**CERTIFICATE OF APPROPRIATENESS**

**Property:** 1024 E.16<sup>th</sup> Street, Lot 4, Block 109, North Norhill Subdivision. The property includes a historic one-story wood frame 1,148 square foot single-family residence situated on a 5,000 square foot (50' x 100') interior lot.

**Proposal:** Alteration – One-story rear addition and alterations to the existing front porch.

**NORTH ELEVATION – FRONT FACING E.16<sup>TH</sup> STREET**

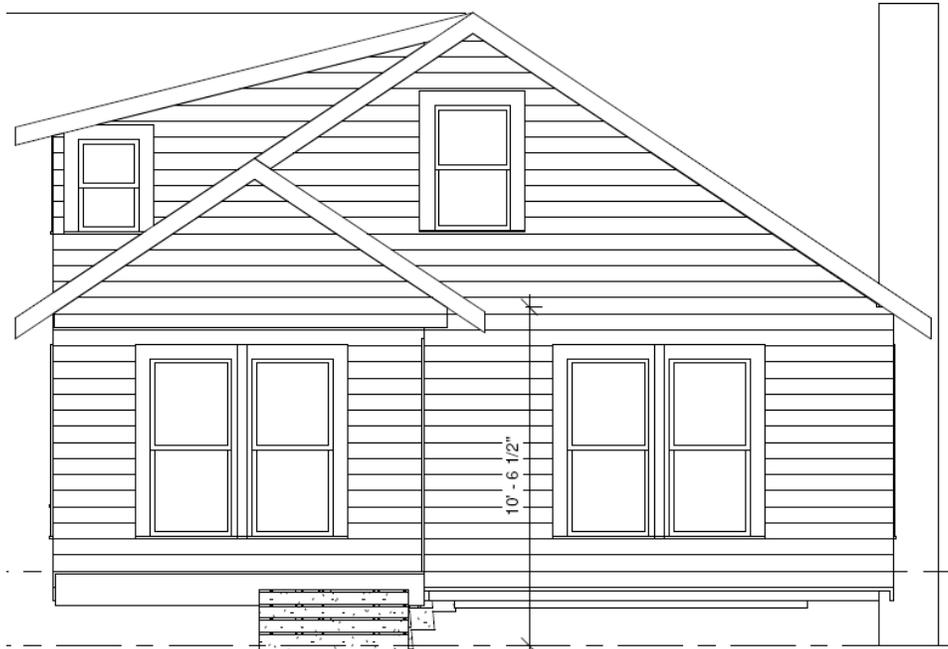
*Note: The proposed drawings show the installation of a brick veneer foundation skirting and brick veneer atop the concrete steps; the drawings are inaccurate and do not reflect the wishes of the property owner. No brick veneer will be installed on the concrete porch or concrete steps.*

*Staff would not recommend approval on the installation of the brick veneer foundation skirting and the brick veneer atop the concrete steps as a condition that was never present on the residence, it alters the existing stylistic exterior feature of the porch, and is not a typical porch condition found in the historic district.*
